Modification Recommended Service Note

Supersedes:
11713D-01

11713D Attenuator / Switch Driver

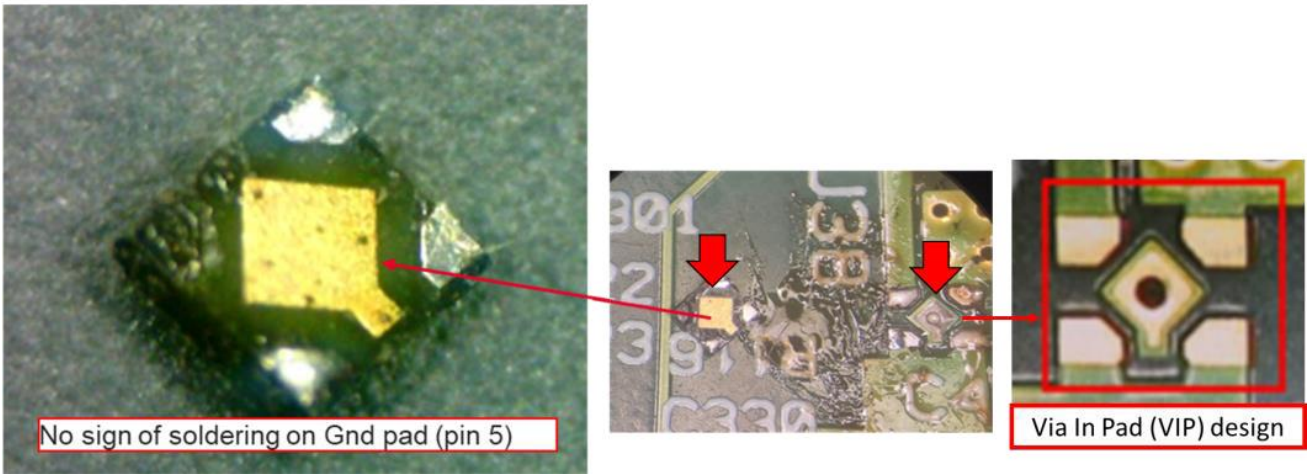
The instrument is unable to boot up and is stuck on the boot-up screen as follows. It is not functioning.

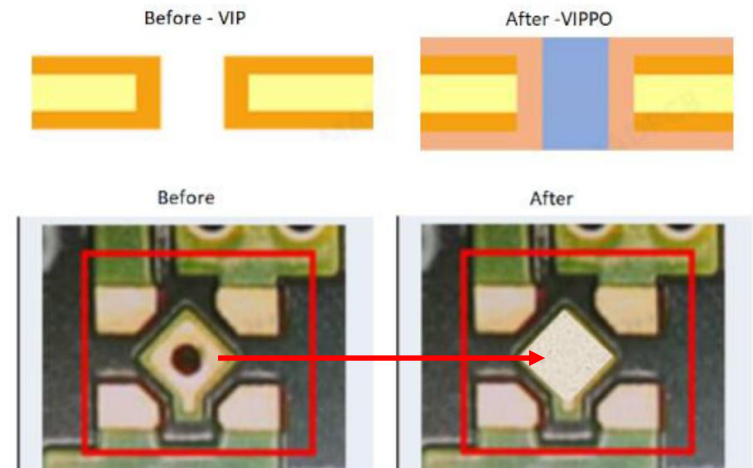
Failure analysis had indicated defective on P0600-63004 board where insufficient solder was observed at 2 locations. The insufficient solder was due to Via in Pad (VIP) where the melted solder had flown to the secondary side of the PCB.

The improvements were made from Via in Pad (VIP) to Via in Pad Plated Over (VIPPO) as per below.

The improved PPMC board have Serial number P06006300423**2413**000007 onwards.

Replace PPMC board P0600-63004 with Programmed PPMC board serial number P06006300423**2413**000007 onwards where 13 is the work week and 24 is the year.
